R18ZF

## SECOND FINAL NOTICE

**DATE:** July 3, 2019  
**TO:** Blue Bird Owners  
**Subject:** Recall R18ZF, Ford 6.8L GEN4 With Optional Throttle Interlock & Actia Instrument Cluster (Roush)

**SUBJECT: Recall R18ZF, Ford 6.8L GEN4 With Optional Throttle Interlock & Actia Instrument Cluster (Roush)**

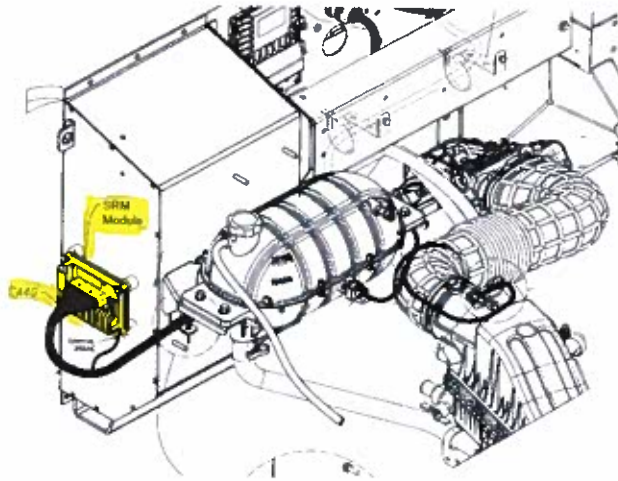
1. Connect your pass-through device to your laptop and your buses OBDII port.
2. Open RDT (you must be connected to the internet).
3. Once RDT opens, ensure your pass-through device is selected in the top left of the screen. To change your pass-through device, simply choose another from the drop-down menu and you will be prompted to re-start RDT for the changes to implement.
4. Select 'Vehicle ID' from the left task menu.
5. Select 'Module Programming'.
6. Select SRM Flash.
7. Select 'update' from the menu at the bottom of the screen. Take notes of the current engine hours from the instrument cluster and record. When the 'enter the engine hours' message is present on the next screen, enter the recorded engine hours in the provided space to ensure that it will not be erased when the flash occurs.
